#### **URGENT - FIELD SAFETY NOTICE**

#### **ARJOHUNTLEIGH SARA COMBILIZER**

Field Correction Notice: FSN/POZ/002-2016

# Addendum to Sara Combilizer Instructions for Use

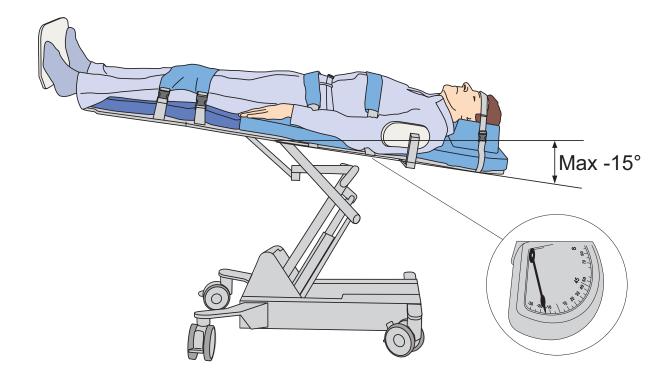
# **WARNING**

To avoid risk of injury do not place Sara Combilizer with patient in head down tilt greater than -15°.

Degree of tilt can be assessed on the tilt angle indicator located under the head section of the Sara Combilizer.
